BROWNS FERRY NUCLEAR PLANT (BFN) - UNITS 1, 2, AND 3 - TECHNICAL SPECIFICATIONS (TS) CHANGE 421 - FRAMATOME FUEL DESIGN AND STORAGE

Technical Specifications (TS) Change 421 Framatome Fuel Design And Storage

Proposed Technical Specifications Changes (mark-up)

4.2.1 Fuel Assemblies

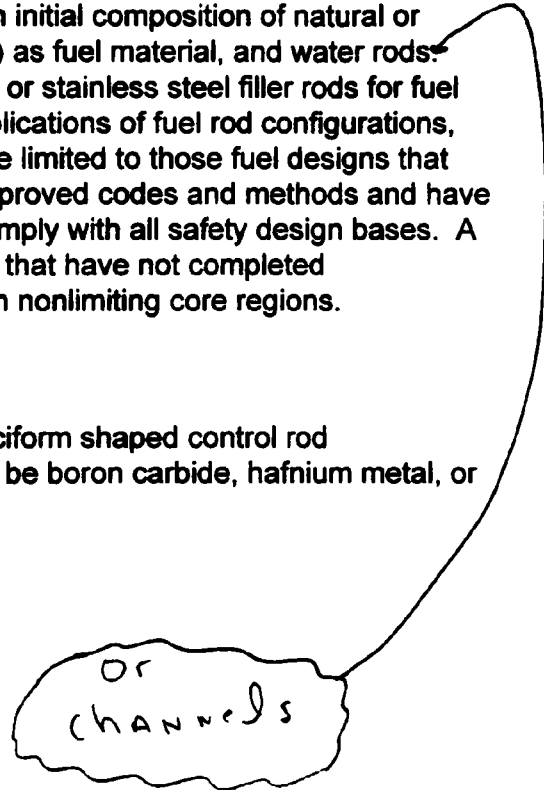
The reactor shall contain 764 fuel assemblies. Each assembly shall consist of a matrix of Zircalloy fuel rods with an initial composition of natural or slightly enriched uranium dioxide (UO_2) as fuel material, and water rods. Limited substitutions of zirconium alloy or stainless steel filler rods for fuel rods, in accordance with approved applications of fuel rod configurations, may be used. Fuel assemblies shall be limited to those fuel designs that have been analyzed with NRC staff approved codes and methods and have been shown by tests or analyses to comply with all safety design bases. A limited number of lead test assemblies that have not completed representative testing may be placed in nonlimiting core regions.

or
channels
